SUBJECT: **Finisher Tray Control**

DATE: Nov. 15, '93

MODEL: F200 X Finisher

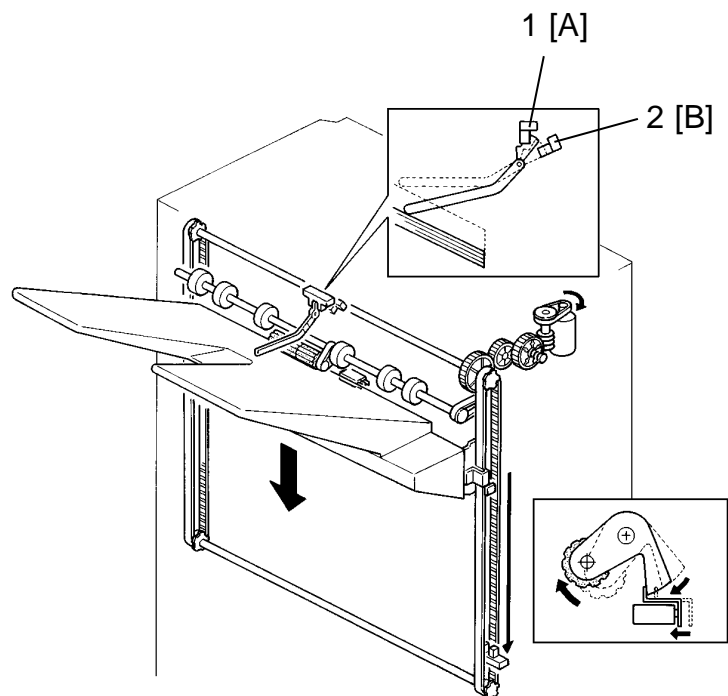
As the field's request to enable the tray to raise up in the above situation, new tray control software has been added to the current software. The new operation software runs only when you turn on DIP SW 101-1 on the finisher main PCB. Note that the factory setting of DIP SW 101-1 is off.

The part number of the EPROM has been changed from A3535120 to A3535130. The part number of the main PCB remains the same.

The tray position is controlled by referring to two stack height sensors, 1[A] and 2[B].

When the copies are removed from the tray during a continuous copy run, stack height sensor 1 [A] is actuated. Then the tray drive motor lifts the tray up until height sensor 2 [B] is actuated.

However, height sensor 2 will be actuated when the following copies are fed out to the tray. Therefore, the tray lift operation is stopped while sensor 2 is actuated by the copy. The tray resumes its lift operation until sensor 2 is actuated.

If sensor 2 is actuated for 3 seconds or more, the machine determines that the tray has been lifted to the upper limit, and lowers the tray for 50msec (Approx. 1mm).
